Access Compliance Report

Public Rights-of-Way

(Curb Ramps)

Intersection ID: 31258	Main Street: CHACEVIEW_CT	Cross Street: SUNSET_RIDGE_CT	Location: E
ADA ID: 1750B7642194	Ramp Type: Perp	Initial Pass/Fail: Fail	Overall Compliance: No
Severity Score: 8.75			
Codes/Mitigation Info/Possible Solution		Field Measurements/Component Compliance

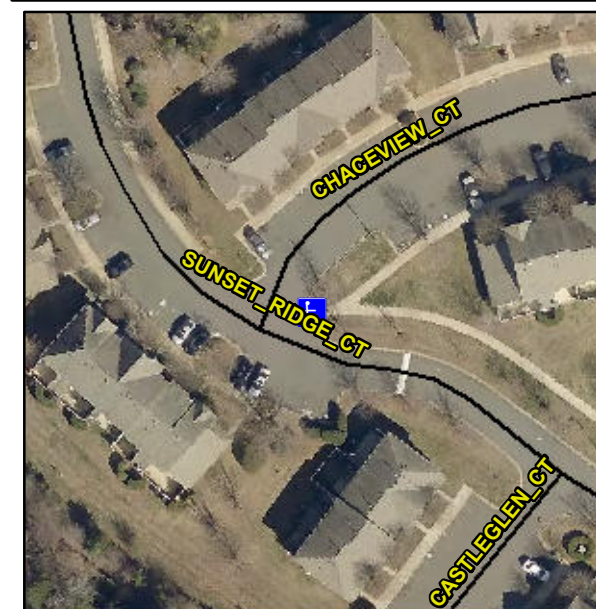
PROW/ADA:

Not Found, R304.5.1

Compliance	Description	Data	Compliance	Description	Data
N/A	Ramp Length (in)	47.0	Yes	Ramp Slope (%)	6.7
No	Ramp Width (in)	46.5	Yes	Ramp XSlope (%)	1.5
N/A	Flare Type LT	N/A	N/A	Flare Type RT	N/A
N/A	Flare Slope LT (%)	N/A	N/A	Flare Slope RT (%)	N/A
N/A	Flare Traversable LT?	N/A	N/A	Flare Traversable RT?	N/A
N/A	Landing Length (in)	N/A	N/A	DWS Provided?	N/A
N/A	Landing Width (in)	N/A	N/A	DWS Contrast?	N/A
N/A	Landing Slope (%)	N/A	N/A	DWS Length (in)	N/A
N/A	Landing X Slope (%)	N/A	N/A	DWS Full Width?	N/A
N/A	Landing Curb? (Y/N)	N/A	N/A	DWS Offset (in)	N/A
N/A	Shared Landing?	N/A			
N/A	Gutter Ponding?	N/A	N/A	Gutter Slope (%)	N/A
N/A	Gutter Lip Ht (in)	N/A	N/A	Gutter X Slope (%)	N/A
N/A	Painted X Walk1?	No	N/A	Painted X Walk2?	N/A
	X Walk 1 Direction	To NW		X Walk 2 Direction	N/A
N/A	X Walk 1 Width (in)	N/A	N/A	X Walk 2 Width (in)	N/A
	X Walk 1 Slope (%)	8.1		X Walk 2 Slope (%)	N/A
	X Walk 1 X Slope (%)	2.0		X Walk 2 X Slope (%)	N/A

Possible Solutions:

Remove & Replace Entire Ramp.
